EQUIPMENT SERIES: 51S

BULLETIN NO. 1

EQUIPMENT TYPE: RECEIVERS 51S-1/1F

SUBJECT: SUPPRESSION OF UNWANTED OSCILLATIONS IN LOW LEVEL AUDIO OUTPUT LINES
AND ALLOW USE OF WIRING CONFIGURATION SHOWN IN FIGURE 1-2.a OF
INSTRUCTION BOOK

Figure 1. Terminal Designation of Transformer T4 in 51S-().

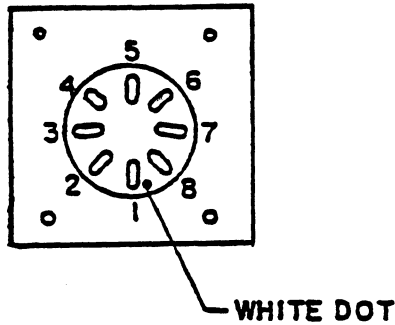
3. Refer to figure 1. Terminals 3 and 6 of T4 have two shielded wires on them and terminals 4 and 5 have only one shielded wire on them. Disconnect the wires from terminal 3 of T4 and connect to terminal J of TB9.

4. Disconnect the wires from T4 terminal 6 and connect to terminal H of TB8.
5. Connect one of the 220-ohm resistors (745-0725-00) between terminal 3 of T4 and terminal J of TB9. Connect other 220-ohm resistor between terminal 6 of T4 and terminal H of TB8.

6. Remove the white-brown-red-blue wire from T4 pin 5 and connect to TB8 terminal B. Connect the no. 22 AWG white-brown-red-blue wire (439-7057-00) to TB8 terminal B and J7, EXT RF GAIN.

51S-1 HF Receiver, Partial Schematic Diagram
Figure 1

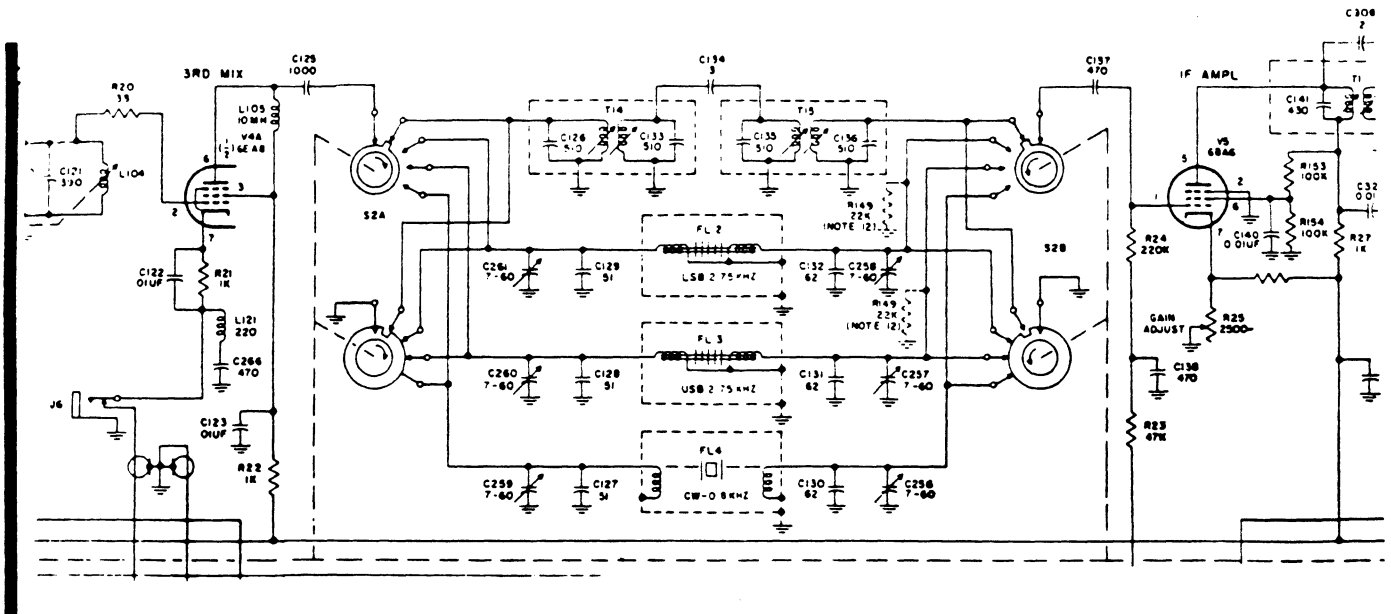
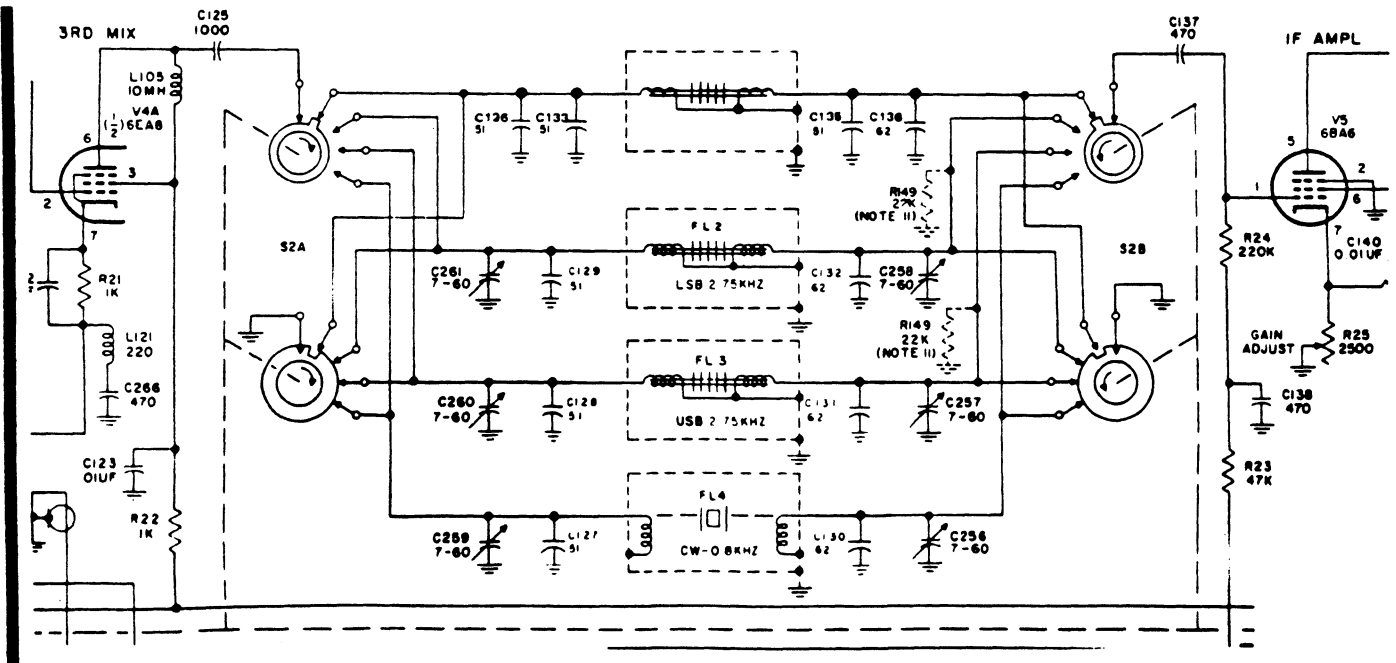
NOTE: The modification procedures depend upon the circuit configuration of the receiver. Configuration A in figure 1 shows fixed resonating capacitors (C127 through C132) across the input and output of each filter. Configuration B in figure 2 is the same circuit except C127 through C132 are removed and resonating capacitors C127 and C130 are switched to the input and output of the selected filter.

b. Disconnect from S2B, the wire which was at T15. For configuration A, connect wire (421-2220-000) and parallel 51 pF (912-3858-000) and 62 pF (912-3864-000) capacitors to S2B as shown in figure 1.

c. Disconnect from S2A, the wire which was at T14. For configuration A, connect wire (421-2220-000) and parallel 51 pF (912-3858-000) capacitors to S2A as shown in figure 1.

51S-1 HF Receiver, Partial Schematic Diagram
Figure 2

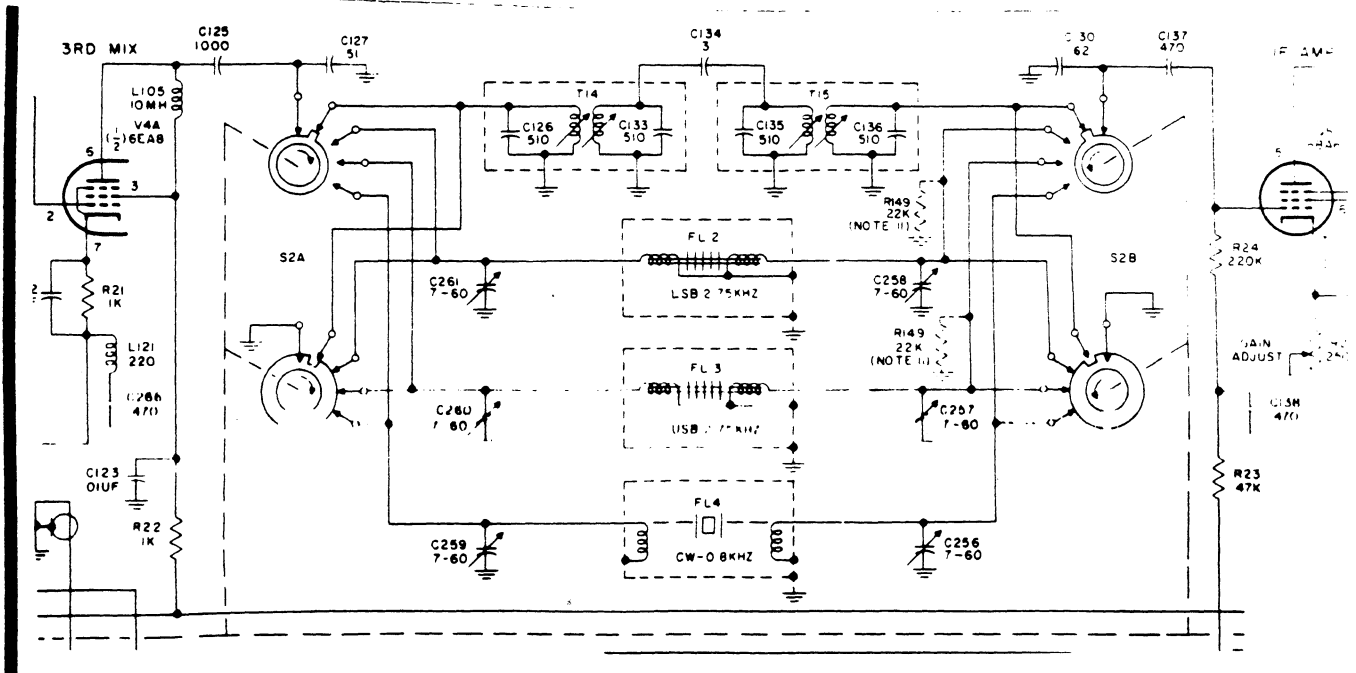
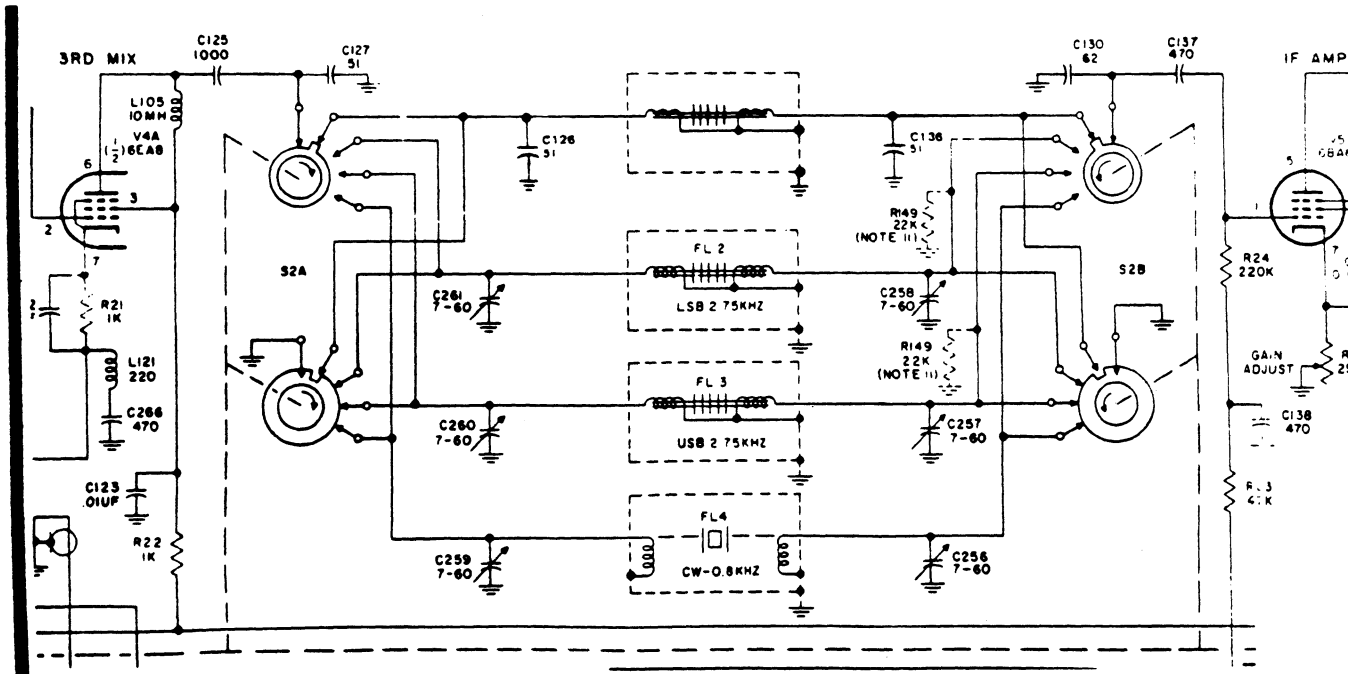
For configuration B, connect wire (421-2220-000) and 51 pF (912-3858-000) capacitor to S2B as shown in figure 2.

For configuration B, connect wire (421-2220-000) and 51 pF (912-3858-000) capacitors to S2A as shown in figure 2.

28-Vdc Power Supply, Bottom View, Terminal Location

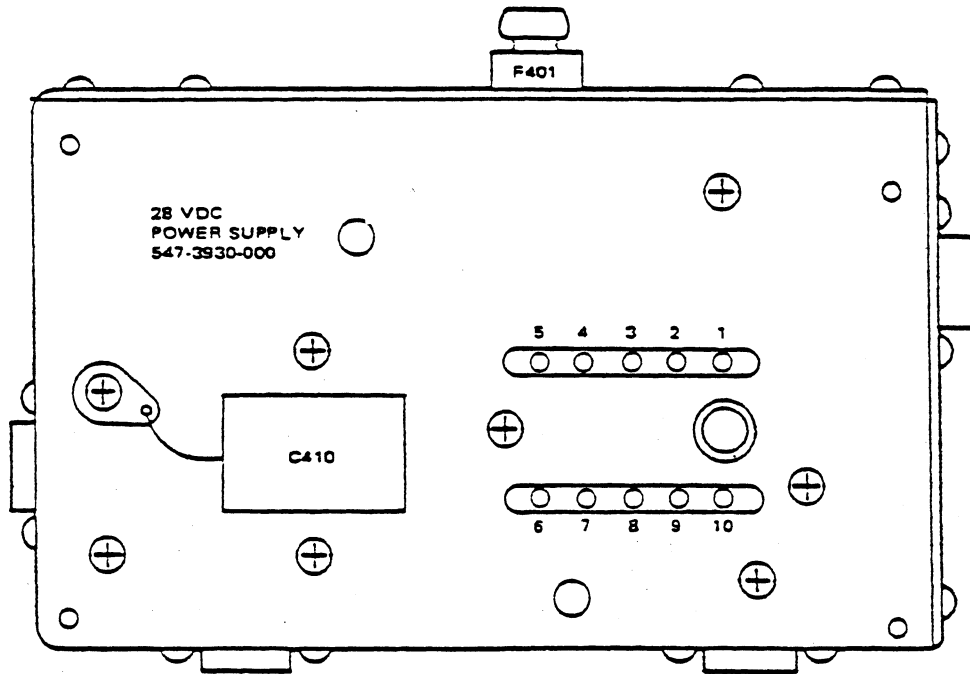
2. Disconnect the following wires from the 28-Vdc power supply and let the wire ends hang free. See illustration for aid in locating terminals.

7. Connect and solder the following wires to the dc supply (refer to note in modification procedure A). Use illustration for aid in locating terminals.

<u>WIRE AWG SIZE AND COLOR</u>	<u>WIRE QUANTITY</u>	<u>CONNECT TO</u>
#16 white-red	1	Terminal 1
#16 white-black	1	Terminal 10
#22 white	1	Terminal 8
#22 white-red	3	Terminal 2
#22 white-orange	2	Terminal 4
#22 white-brown-green	2	Terminal 6
#22 white-black-red-blue	2 or 3	Terminal 5

NOTE: The illustration on page 6 is a 51S-1/1F partial schematic diagram showing the modification changes.

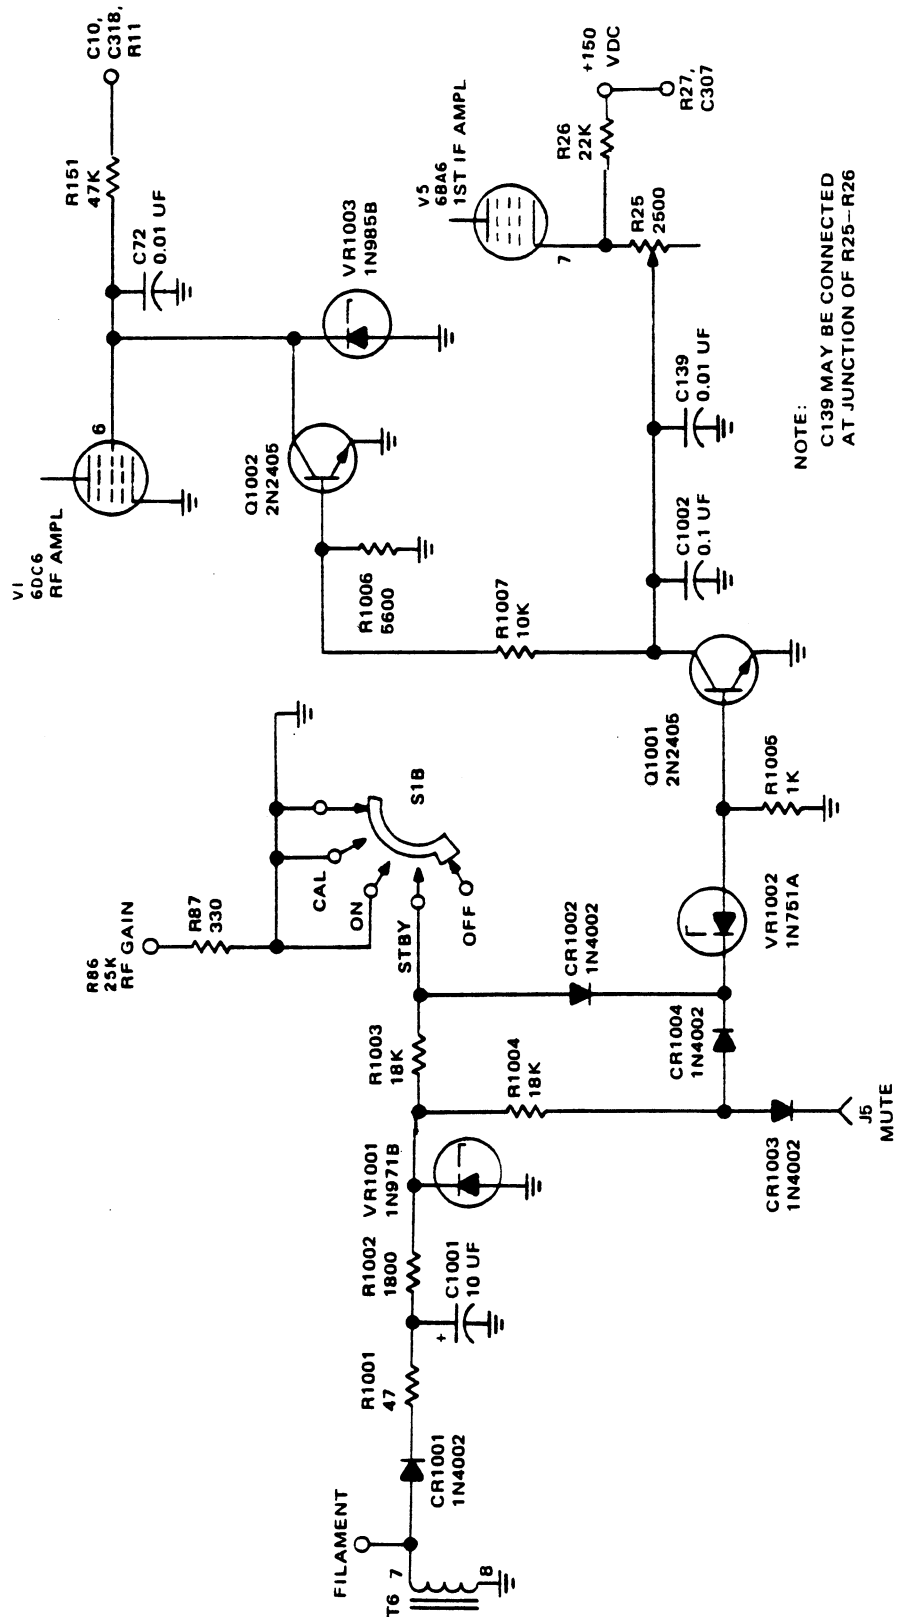
- b. Disconnect the wires from mute jack J5 (figure 6-3, page 6-14) and reattach them to a nearby ground post. Remove and discard 0.01 μ F capacitor C323.

- c. Remove the shield cover over the bottom of the 51S-1.
- d. Remove existing 47-k Ω , 1/2-watt resistor R151 (V1 screen-grid resistor), and replace with new 47-k Ω , 1-watt resistor (745-3422-000).

- e. Connect a #22 orange wire (439-3033-000) to XV1-6, route other end out of rf section at rear of chassis, and connect to TB6-B.
- f. Replace shield cover removed in step c.

- g. Connect 1N4002 diode CR1001 (353-6442-020) from T6-7 (anode end) to TB12-H (cathode/banded end).
- h. Connect 47-ohm, 1/4-watt resistor R1001 (745-0701-000) from TB12-H to TB12-C.
